TE Connectivity

Product Change Notification: PCN-25-245083

K1007167, K1160177, K1150879

General Description of Changes

Old Kissling Customer format

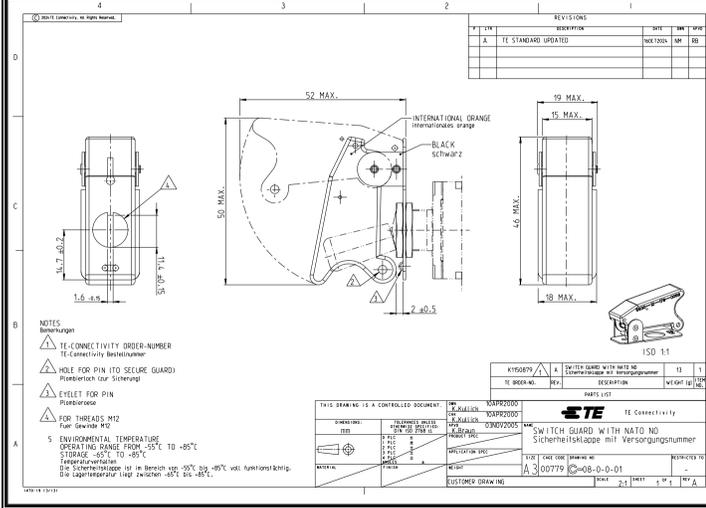
The Industrial and Commercial Transportation business unit of TE Connectivity is introducing an adjustment on customer drawings for the part number(s) listed below. These PNs are TE proprietary designs, therefore considered catalog/general market product and customer restricted product. This change has no influence on Form, Fit, Function, it is only document change. And for this TCPN K1150879 BOM Table Update

Zone B1 - K1150879

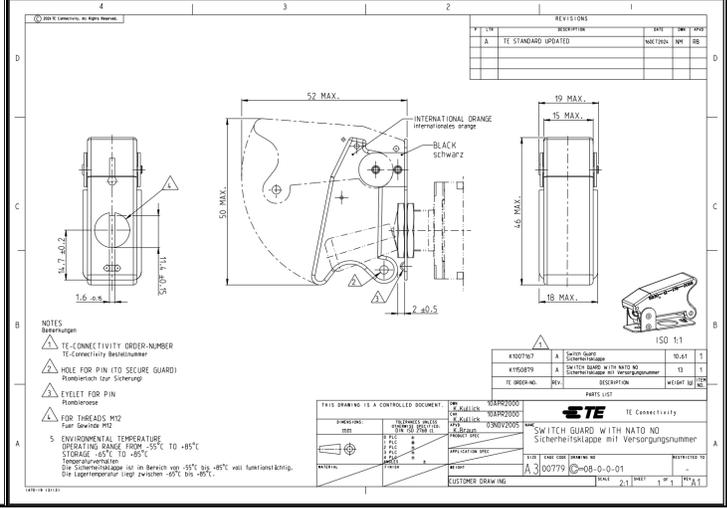
Zone B1 - New TCPN K1007167 is Added to the table
